Office Action Summary

10/528,215

SALOMON-BAHLS, BERND

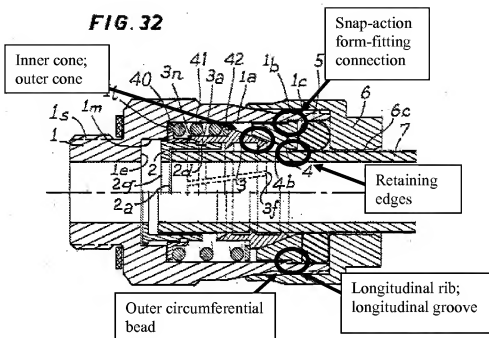
With regard to claim 21, and as seen in Figure 32 below, Legris discloses a connecting device for a plug-in connection for at least one pipeline, the plug-in connection comprising a housing part (1, 4) having at least one receiving opening (1a) for the insertion of the pipeline, a

clamping ring (3) arranged in the receiving opening and, in order to lock the pipeline in place within the receiving opening, an outer cone surface of the clamping ring interacts with an inner cone surface of the housing part, the housing part being made in two parts from a base part (1) and an insert part (4) which is connected to the base part via a snap-action form-fitting connection which includes the inner cone surface, and the insert part having a dirt seal (5) for resting on the circumference of the pipeline in place within the receiving opening.

However, Legris does not disclose that the insert part is of a first, relatively hard and dimensionally stable plastic material or that the dirt seal is of a second relatively soft and elastic plastic material or that the second material is attached directly onto the first material to form a single piece with a material joint therebetween. Wallace et al teach that an adhesive can be placed on the seal to attach it securely and firmly to another structural element such as an insert part so that the seal cannot be accidentally separated from the insert part during transportation or assembly.

With regard to claim 32, and as seen in Figure 32 above, Legris in view of Wallace et al disclose the insert part having positioning means on its outer circumference for the automatic aligning on insertion into the base part, the positioning means being at least one radially projecting longitudinal rib which runs axially in the insertion direction and engage in a corresponding longitudinal groove of the base part.

With regard to claim 33, and as seen in Figure 32 above, Legris in view of Wallace et al disclose retaining edges within the insert part following the inner cone as an axial end stop for the clamping ring.

With regard to claim 36, and as seen in Figure 32 above, Legris in view of Wallace et al disclose that the insert part (4), for the circumferential sealing toward the base part, can be inserted into the base part with a press fit and has an outer circumferential sealing bead.

With regard to claim 37, and as seen in Figure 32 above, Legris in view of Wallace et al disclose the circumferential sealing bead of the insert part being attached to the insert part with a material to form a single piece but does not disclose that the circumferential sealing bead consists of an elastic material.

Examiner disagrees. See Figure 32 above for the snap-action form-fitting connection. What is Applicant defining as a snap-fit connection? Applicant claims a snap-action form-fitting connection between the base part and the insert part and not a "snap-fit connection". The base part and insert part of Legris are form-fitting together and have a "snap-action" when assembled.
